Service data bulletin

Instrument: Transceiver unit DL850T27-SB
SDB no: SDB_DL850_11

SUBJECT: On a batch of Back plane PCBs washers are mounted which should not have been mounted. This washer may lead to short circuit in the PCB.
The transceiver unit serial numbers in this batch are:
DT-10618 to DT-10622, DT-10625.
SK SK111000228, SK311000259 to SK371000264, SK371000266 to SK371000274 and SK421000278.

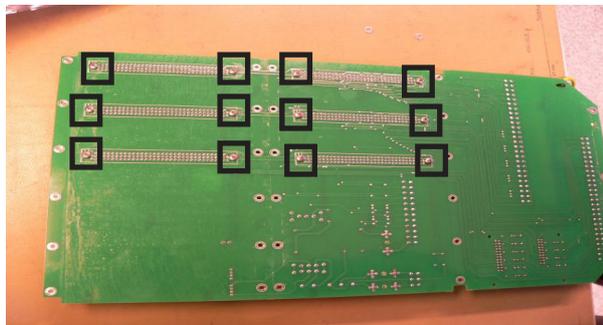
Washers are mounted on the back side of this Back Plane PCB.
3 PCBs, Eurocase and transformer have to be removed before PCB can be taken out.

The washers are mounted under the screws for the connectors, two for each connector, a total of 12 washers.

Not correct.
Washers should be removed

Correct.
No washer
